PLANNING COMMISSION MINUTES

Tuesday, March 1, 2022
6:00 PM

Please see the email below relating to the Council's concerns relating to RZM2021-00032, SUP2021-00057 and SUP2021-00058 (Gwinnett Drive Townhouses).

REZONING SITE PLAN - 3

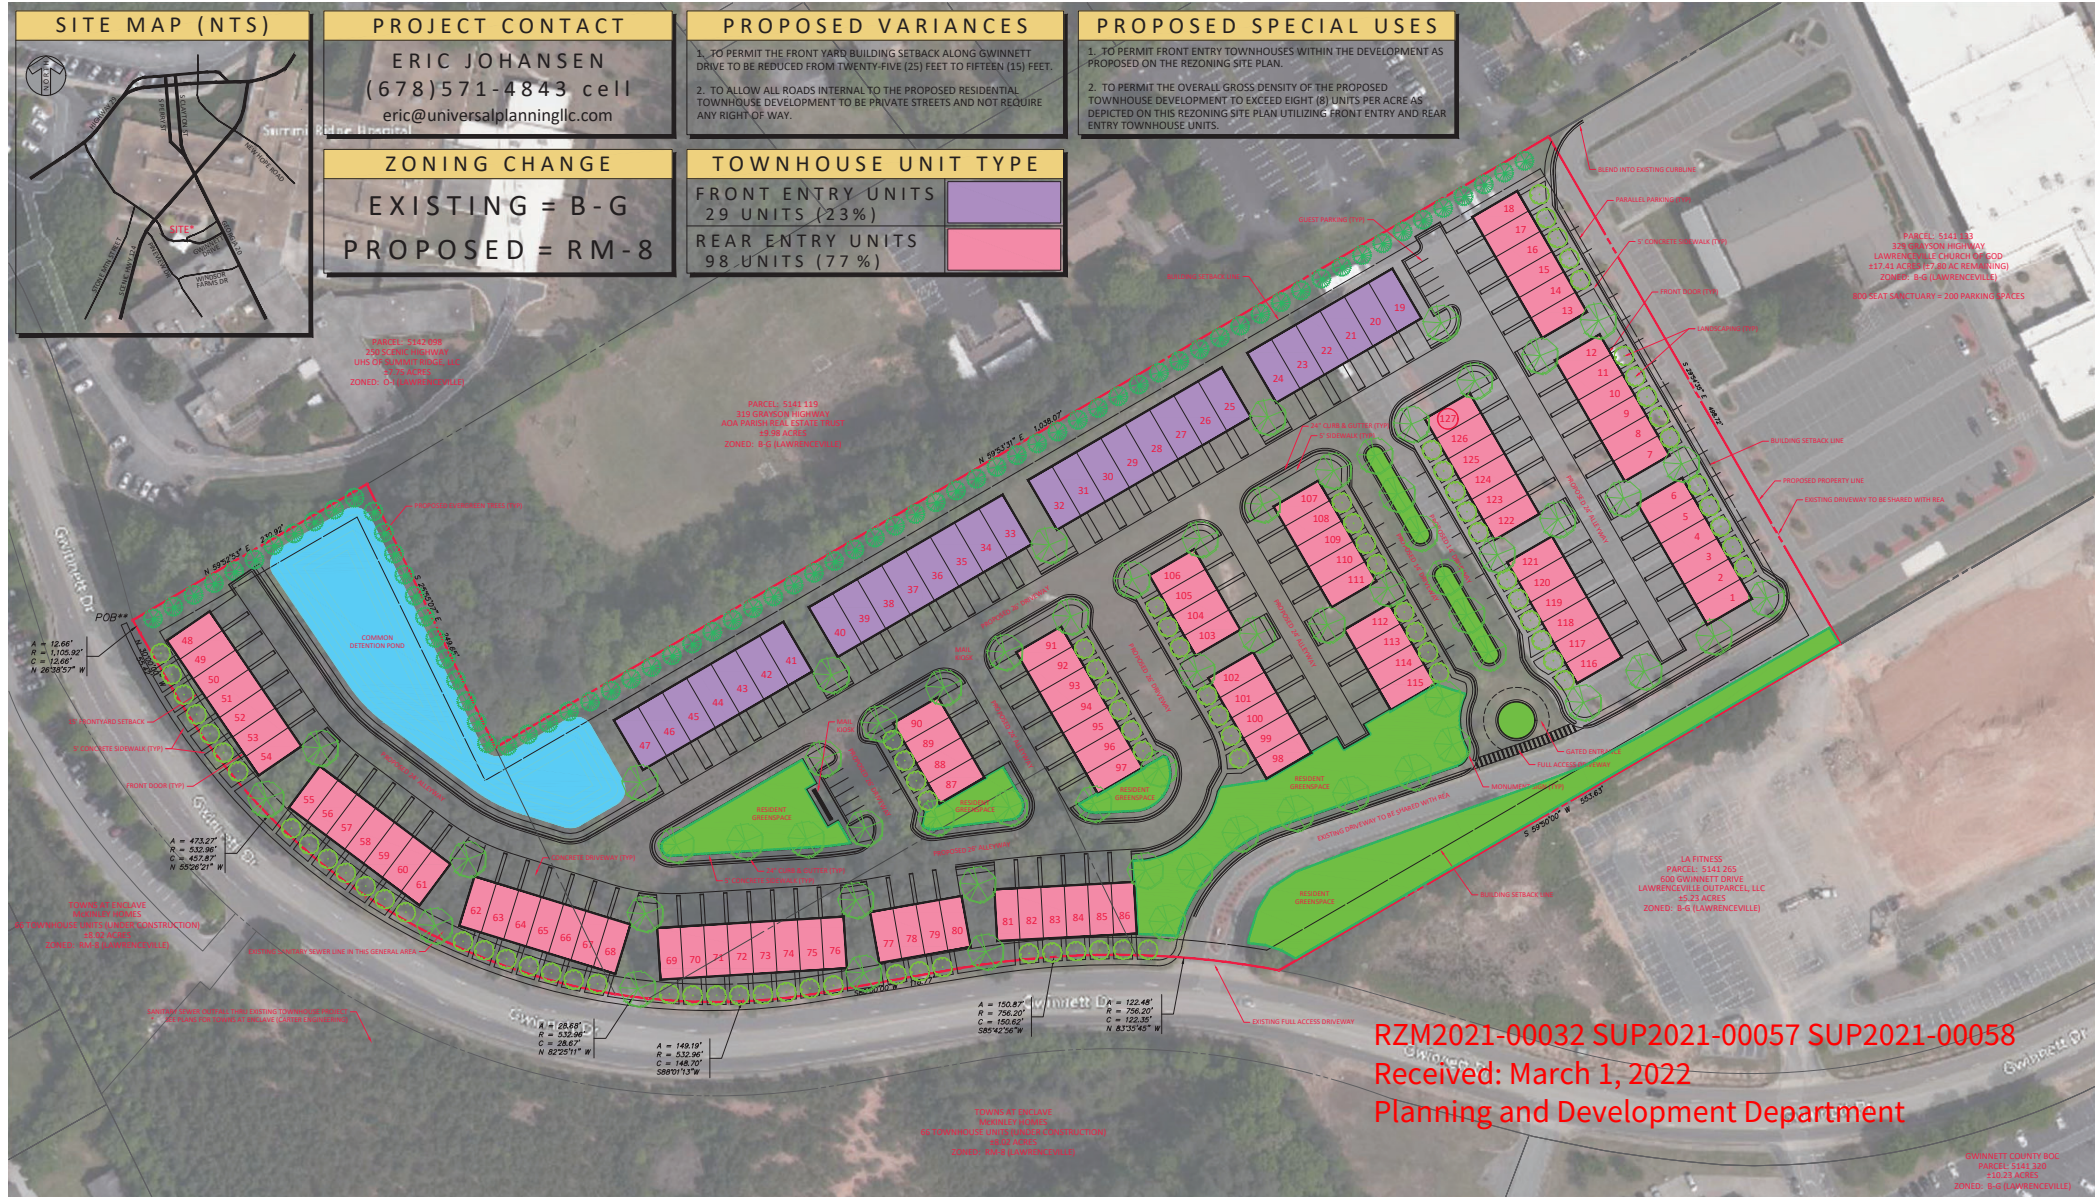
1. She was concerned about having front entry townhomes and the fact that they are generally lower in price. I mentioned that they the footprint was bigger and that I would ask you to provide your thoughts on price points for rear entry and front entry for this development so we can understand the difference in price for a front entry and rear entry. Please advise. The front entry townhouses that are 24' x 50' are two car garages units that will sell for over \$300,000. There are front entry townhouses, I believe, in the City Lawn mixture of residential townhouses. Everything in that market is selling for over \$300,000. Front Entry units also provide the opportunity for a "back yard" patio and outdoor living areas the residents can utilize. Rear Entry units do not provide the same "back yard" area because the "back yard" is the driveway. In some cases the builder will cantilever over the driveway with a wooden deck which is located off the second floor. Front Entry units also provide the builder with the opportunity for Master on Main bedroom configurations when the market is demanding those setups.

2. We did not see any renderings in the packet and Condition 1.C references renderings that will be presented at the March 1 Planning Commission meeting. Please advise of the status of these. We did not provide renderings on purpose when we filed the Applications. The reason being we wanted some flexibility with the future builder to submit their unique building elevations at the time of development permitting with the City. We did however ask for the building conditions related to the proposed architecture to match the same building conditions for the adjacent TH zoned property across the street, which will have units starting over \$300,000 as well. We still are asking the City to be flexible as all builders have different elevations while achieving the same written architectural conditions.

3. There was a concern about the encroachment request into the 25' setback. The point that I remember we talked about was the fact that you were trying to move the front door a little closer to Gwinnett Drive to create a residential, urban, walkable community. Please confirm. Across the street we were granted the same front yard setback encroachment. So in keeping with the Gwinnett Drive streetscape and bringing the front doors closer to Gwinnett Drive we have requested the same. Yes this picks up a little more room on the interior of the property, but that helps us get away from the Catholic Church property corner which pushes into the property with a hard 90 degree angle. Also helps gain more green space on the interior of the overall property.

4. There was a concern about not having enough greenspace for areas to walk a dog, etc. I have two suggestions for making additional greenspace as well as greenspace that is useable and centrally located. See attached for suggestions.

- A. Greenspace #1 – eliminating the drive connection as well as possible elimination of one unit to have a better connection. A version of this could definitely work, great suggestion. There would be a slight modification where we need to join the left and center drives together because the center drive has on street parking and we should not create a dead end situation for traffic flow. By joining these two drives together we can use a larger radius and help open up more useable green space in the same area proposed by the City.

- B. Greenspace #2 – Switching the detention pond with original greenspace. Appears the topo will allow this modification. We have hired Lowe Engineering to perform all surveying and civil engineering. I am copying Helen Simpson on this email and will address this situation prior to the Planning Commission and Work Session Meeting. If we can move it and still handle the existing church storm water and the proposed townhouse development storm water, then we would not have any issues doing this.

5. Condition 2.E indicates that this will be a gated community. Just made a note on the attachment that the entrance may need to be modified to accommodate this. We intend to gate this community, just have not worked thru the actual flow of the gated community with the security system providers. But we have no issues with this proposed condition.

6. Would like for the density to be under 10 units per acre. I did not mark this on the attachment but eliminating units 90-96 would open up the interior greenspace and would accomplish this goal. Would like your thoughts on this. I understand that the reason you are asking for more than 8 units per acre is the fact that you are having to do sewer upgrades (see comment 8). This is anticipated to be just under \$1M right? The latest price we received from Lorraine Campaign at Gwinnett DWR is as follows: *"Using Kurt's plan with a minor alteration to doghouse the line coming down the eastern side of Stone Mt St, the estimate is coming in at \$1.7M. Please note that this number is volatile due to supply chain, easement and by-pass pumping issues/assumptions."* At this point its still a moving target. Obviously we would like to have the 127 units we have proposed which is a mixture of 24' units (front entry) and 20' units (rear entry). We will continue to work with the City and our civil engineers to maximize the "green space" opportunities while providing the units that best fit onto the proposed development, assuming the City provides us with the approvals to do so.

7. If the site plan changes, we need to make sure condition 1.C is modified appropriately.

8. Would like to add condition 2.F to capture the work that you will need to do for sewer upgrades. As we discussed, the City will assist in contacting property owners.

Price Points = from all of the builders I have spoken with who, including our broker, have interest in this project, they all would be constructing units that sell for \$300,000 and higher with the average starting price being closer to \$350,000. With building materials continuing to rise and the exterior elevations conditions we have proposed to the City in our Applications, we believe that \$350,000 will be an easy target to hit with the opening sales pricing of this project.

Agreed.

2.F At no cost to the City of Gwinnett County, developer shall design, acquire easements, and upgrade sanitary sewer main downstream of this project in accordance with direction from Gwinnett County. Having discussed with Jay Williams, we are not prepared to firmly answer this question at this time. Between now and Mayor and City Council Work Session we should be better prepared to discuss.

APPLICANT REDLINES_2.28.2022_CONDITIONS_03012022

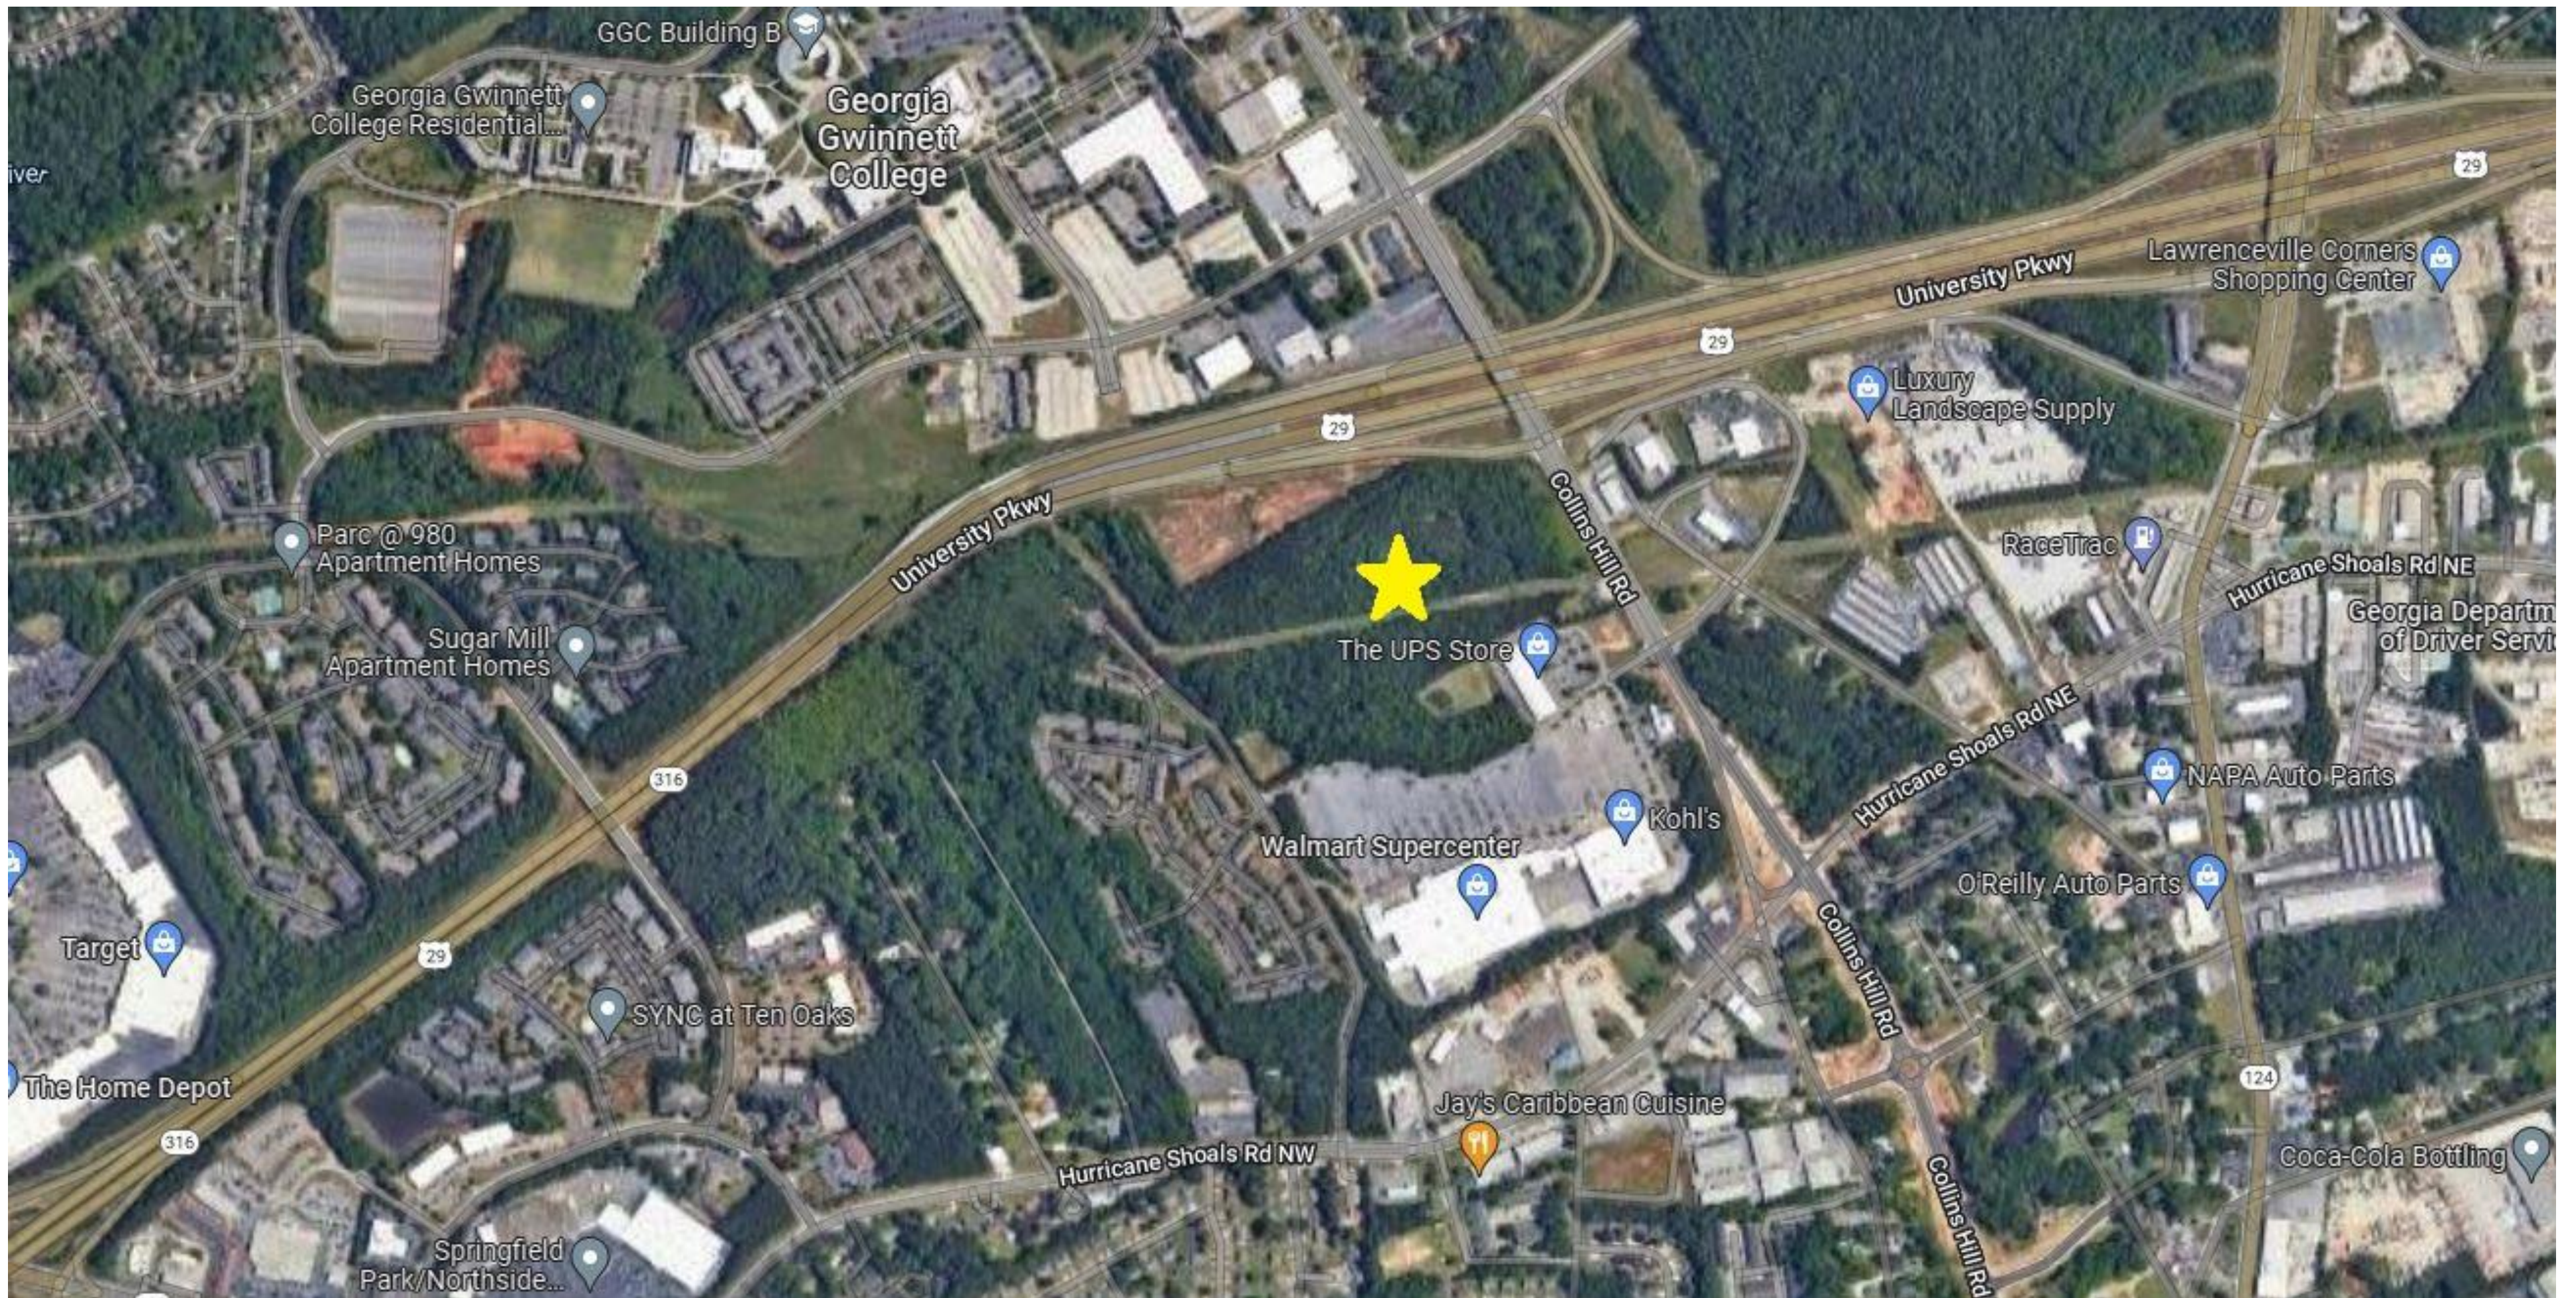
Commented [BR1]: Reference to DRI plan submission, date should be updated if plan is revised before Council approval.

Commented [BR2]: 25 ft. setback will greatly impact commercial section of development.

Existing ROW space along Collins Hill Road and SR 316 exit ramp creates substantial space and distance between the actual public roads and the subject property lines.

Commented [BR3]: With multiple contingencies, including ROW/easement acquisition + pipeline operator cooperation, developer requesting additional flexibility.
